DART AEROSPACE LTD	Work Order:	164150
Description: Crosstube Assembly, Mid Aft	Part Number:	D206-667-247
Inspection Dwg: D206-667-247 Rev: A		Page 1 of 2

DART AEROSPACE LTD HAWKESBURY, ONTARIO, CANADA	
DRAWING NO. D206-667-247	REV. A SHEET 1 OF 4
TITLE CROSSTUBE ASSY (206L MID AFT)	SCALE NTS

DRAWING NO. D206-667-247	TITLE CROSSTUBE ASS'Y (206L MID AFT)	REV. A	DART AEROSPACE LTD ENGINEERING ORDER		D.E.O. NO. D206-667-247-A-1	SHEET NO. SHEET 1 OF 1	SCALE NTS
DRAWN <i>q2</i>	CHECKED <i>ASS</i>	MFG. APPR. <i>KD</i>	APPROVED <i>IMP</i>		DE APPR. <i>#</i>		
DATE 11.07.15	DATE 11.07.20	DATE 11.07.21	DATE 11/07/21		DATE 11.07.21

PURPOSE:

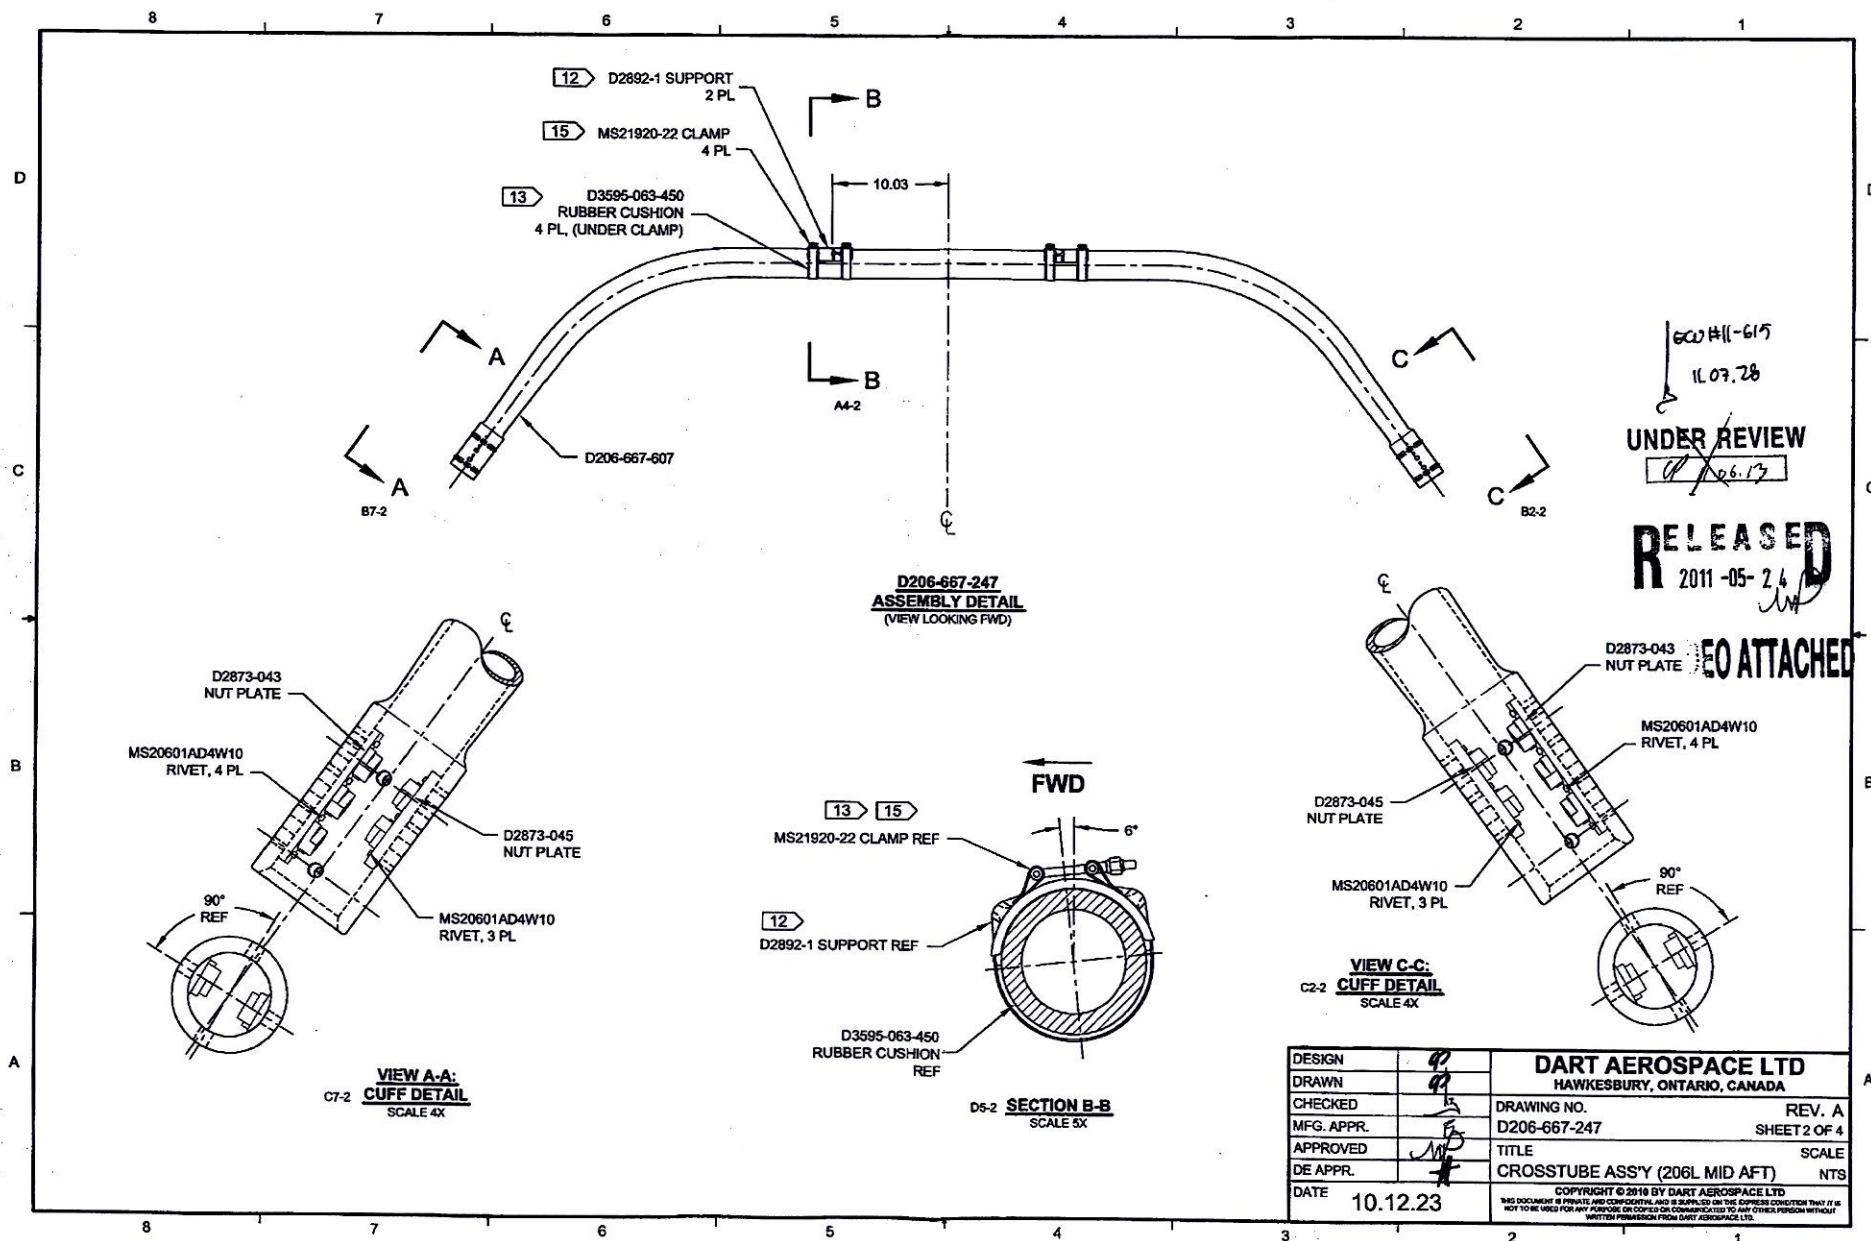
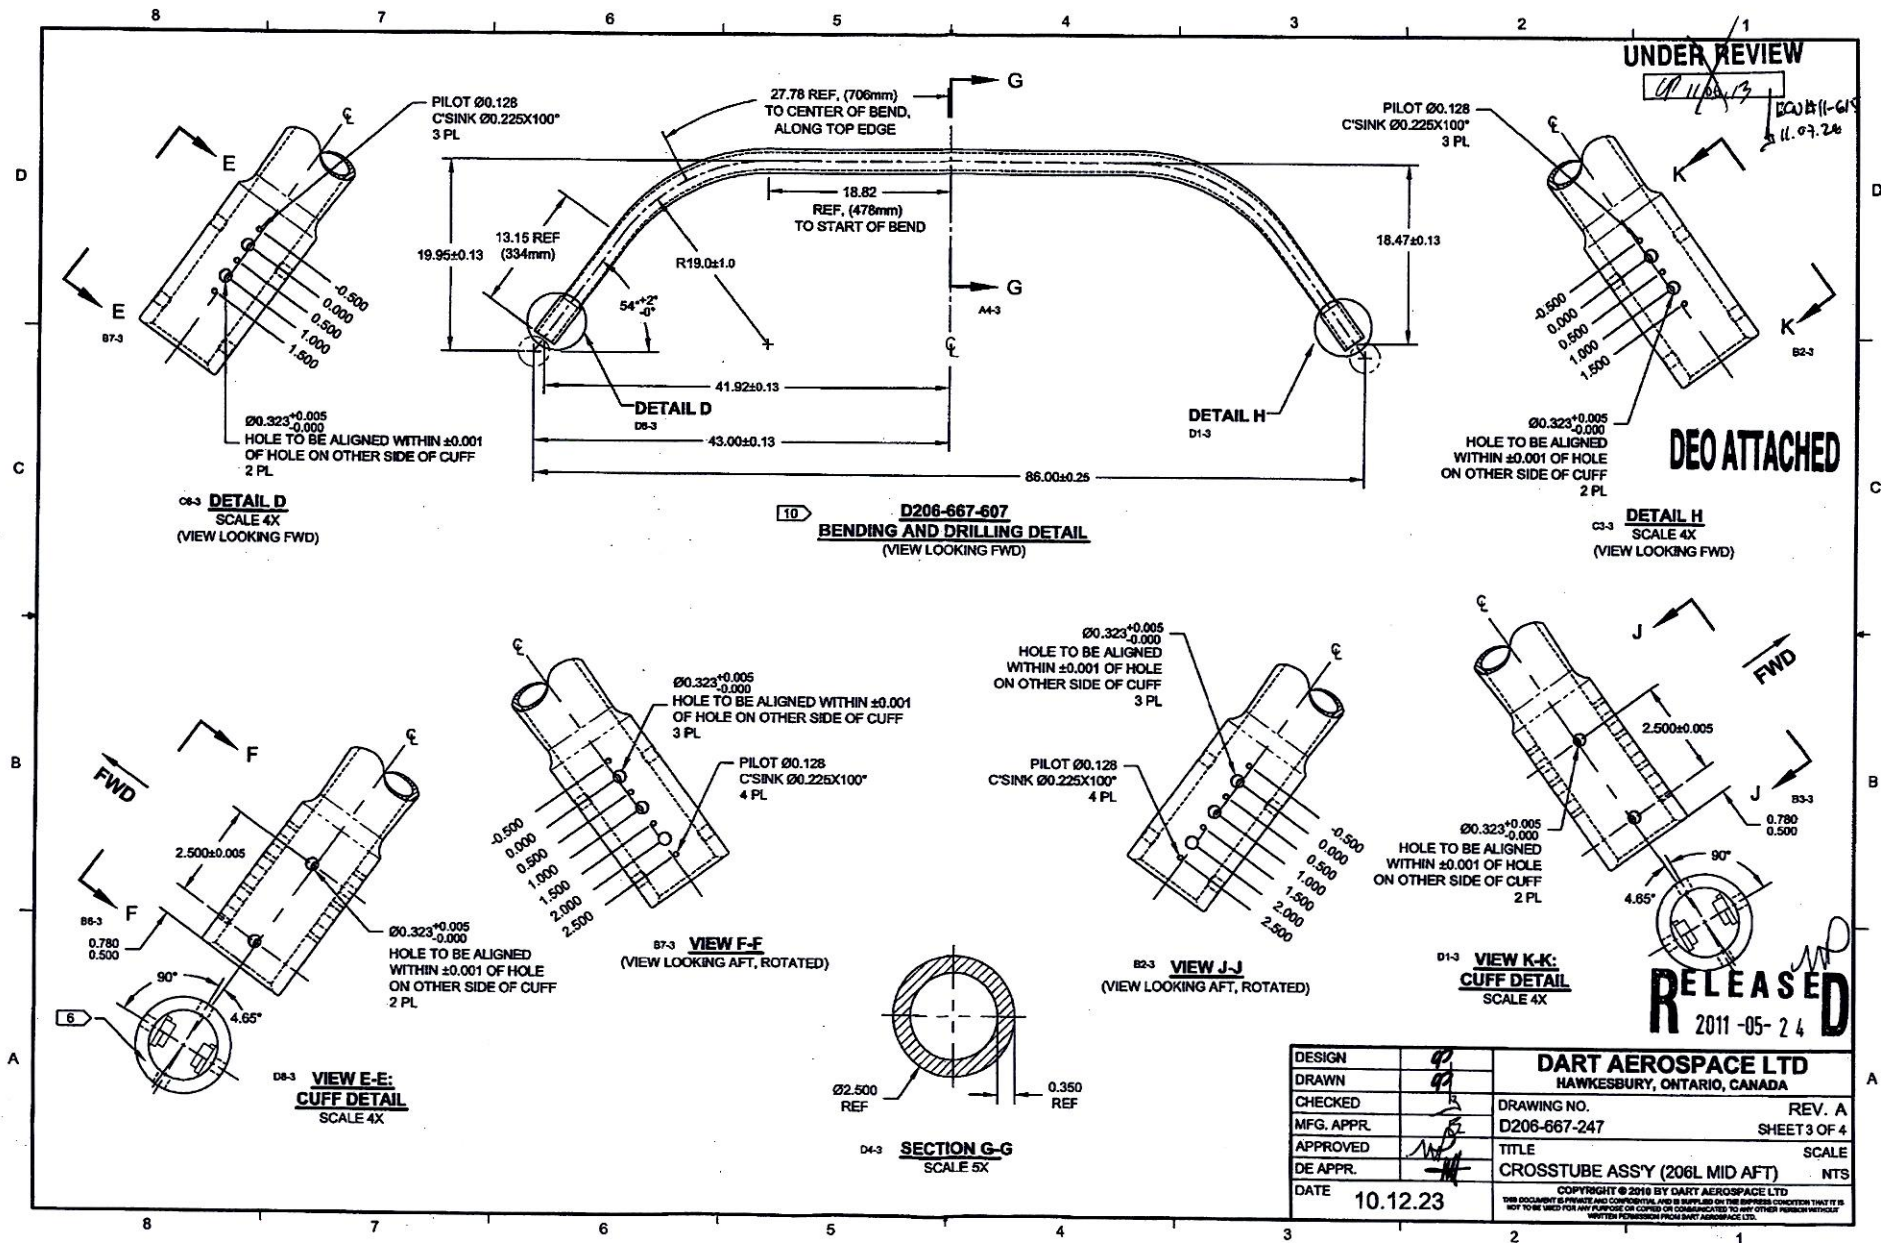
REPLACE MAGNOBOND WITH PROSEAL.

NOTE 12 & 15, SHEET 1 IS AMENDED AS FOLLOWS:

Item	Qty -247	Part Number	Description
9	A/R	PROSEAL 890 B-2	SEALANT, AMS-S-8802 CLASS B-2

- 12) TO INSTALL D2892-1 SUPPORT: ABRASE MATING SURFACE OF SUPPORT AND CROSSTUBE WITH 180-GRIT SANDPAPER AND REMOVE RESIDUE WITH MEK (OR EQUIVALENT). APPLY A 0.04" TO 0.07" THICK LAYER OF PROSEAL 890 CLASS B-2 (OR AMS-S-8802 CLASS B-2) SEALANT TO MATING SURFACE OF SUPPORT.
- 15) TORQUE CLAMPS 80 TO 100 IN-LB. ENSURE AT LEAST 1.5 THREADS SHOWING IN SAFETY AND THAT NUT HAS NOT BOTTOMED-OUT AFTER TORQUING. **PRIOR TO PACKAGING, RE-CHECK TORQUE ON CLAMPS AFTER PROSEAL 890 SEALANT HAS CURED FOR 72 HOURS.**
